0.0 Planning Application PLA19/0038 at Westfield Doncaster 619 Doncaster Road, Doncaster, to amend Planning Permit PLN18/0772 to make alterations to the awning and finishes of Level 2 and reconfiguration of the Level 4 car parking area

File Number:	IN19/361
Responsible Director:	Director City Planning and Community
Applicant:	Contour Consultants Australia Pty Ltd
Planning Controls:	Activity Centre Zone, Schedule 1; Development Plan Overlay, Schedule 4; Development Contributions Plan Overlay, Schedule 1; Parking Overlay, Schedule 1
Ward:	Koonung
Attachments:	1 Decision Plans 2 Legislative Requirements

Figure 2 above: The proposed amendment showing a reduced awning length of 7.1 metres and the retention of the existing finish on the ground level.

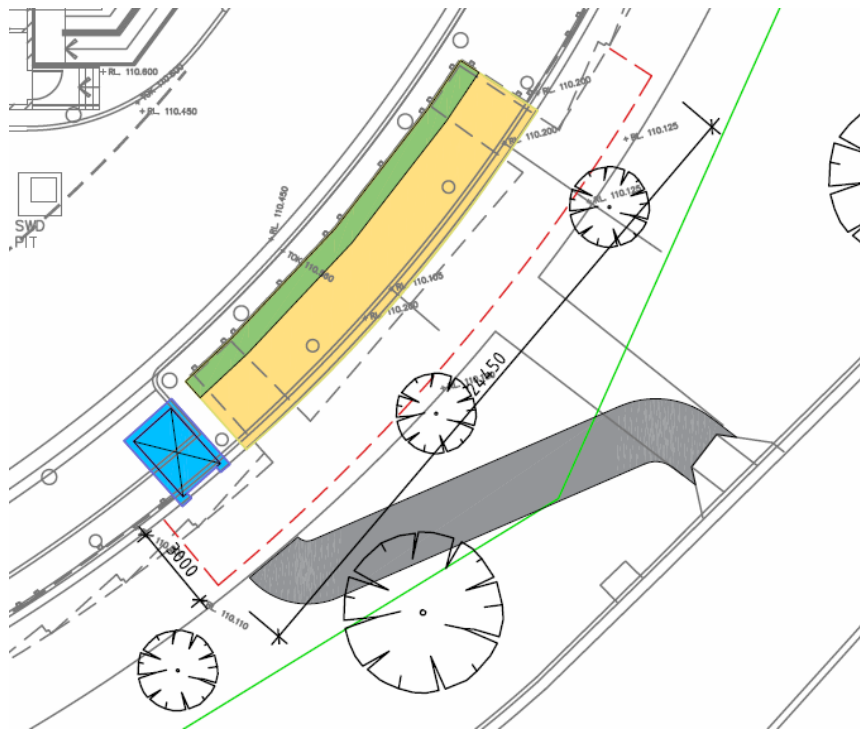
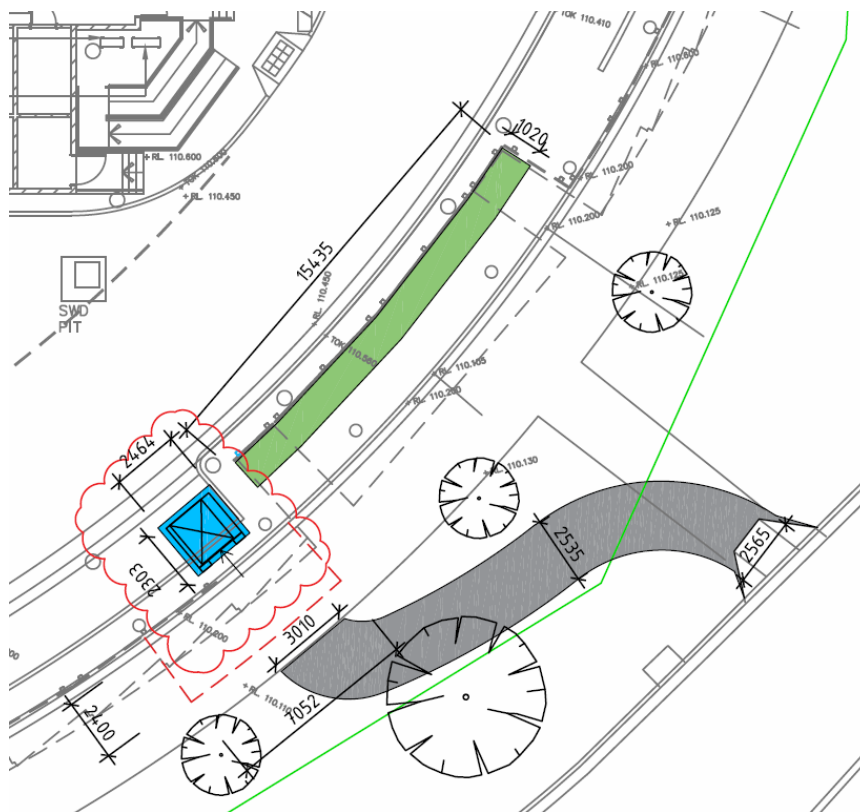
- 8.3 The proposed reduction in the size of the awning will not result in a discernible change to the appearance of the building and will continue to serve the purpose of providing identification and shelter to the lift entry.
- 8.4 The proposed retention of the existing concrete rather than providing a new floor finish at ground level will not result in any additional impacts as it merely involves the retention of the existing conditions.
- 8.5 A comparison of the original approved proposal and the proposed changes to the ground level (Level 2) is provided as follows:

Figure 1 above: The original approved proposal showing the awning length of 24.5 metres and a new floor finish adjacent to the lift and indicated in yellow.

Figure 4 above: The proposed amendment showing two additional kiosks and changes to outdoor seating areas.

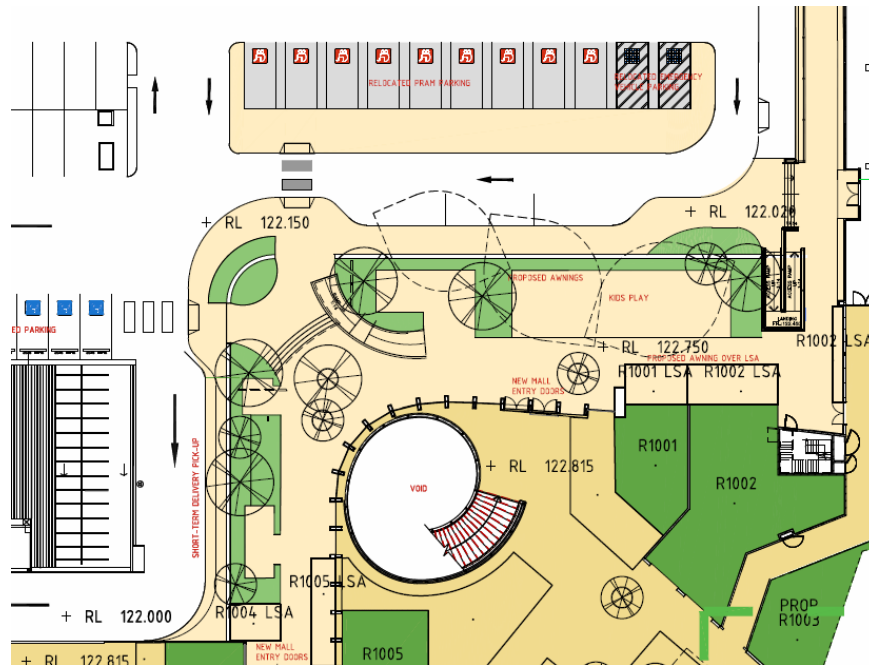
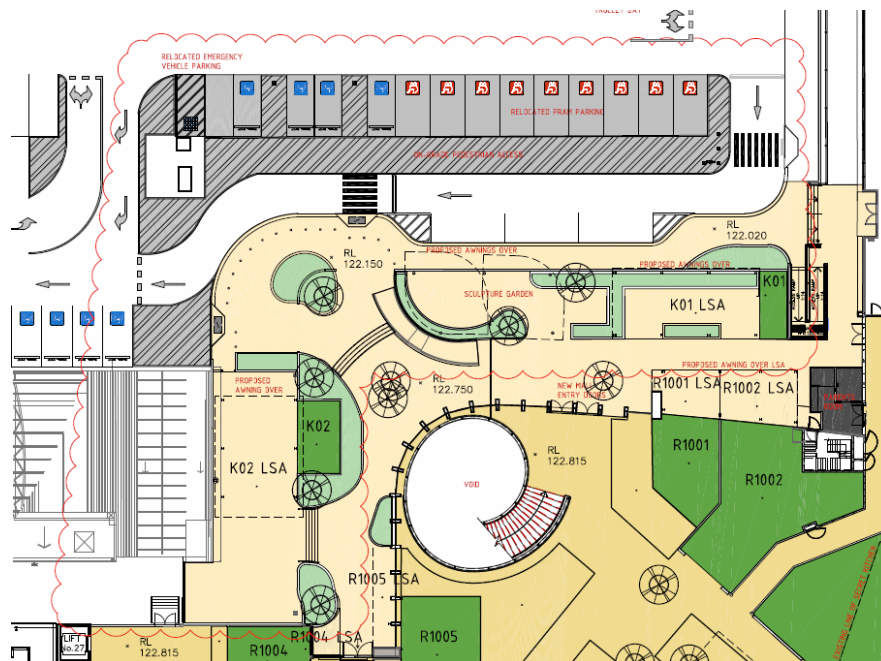
- 8.6 There are also minor alterations to the northern and eastern interfaces of the Level 4, mainly associated with the addition of the two kiosks and slight changes to the size and shape of outdoor seating areas. These changes are minor in nature and will not cause additional detriment to any persons.
- 8.7 A comparison of the original approved proposal and the proposed amendment to Level 4 is provided as follows:
